UNITED STATES PATENT AND TRADEMARK OFFICE

APPLICATION NO.	FILING DATE	FIRST NAMED INVENTOR	ATTORNEY DOCKET NO.	CONFIRMATION NO.
10/536,653	05/30/2006	Christian Kranz	1890-0242	9076

Office Action Summary

DETAILED ACTION

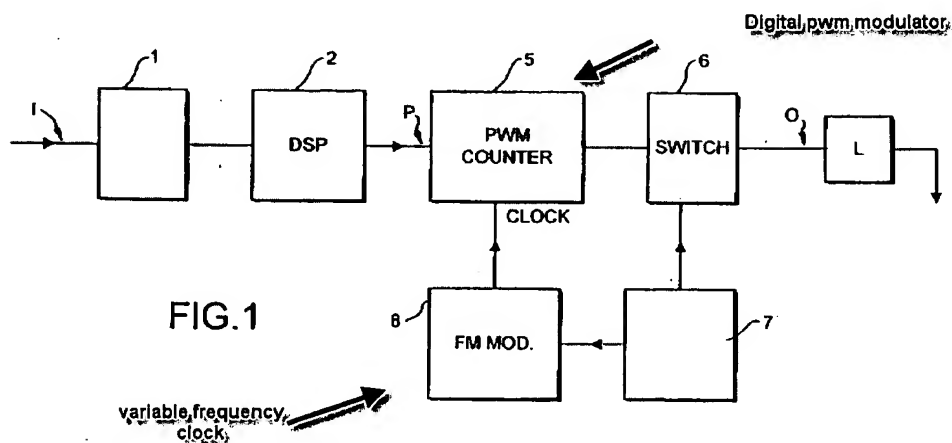
Claim 1 is rejected under 35 U.S.C. 102(b) as being clearly anticipated by Newey US 6,124,757 of record (Newey).

Figure 1 and the relevant text of Newey discloses a method for the correction of signal distortions in an amplifier device where the steps of operating a digital PWM modulator 5 is provided and the step of applying a variable frequency system clock via the element 8 of Newey is provided. Note that the abstract describes the correction of the signal due to the power source.
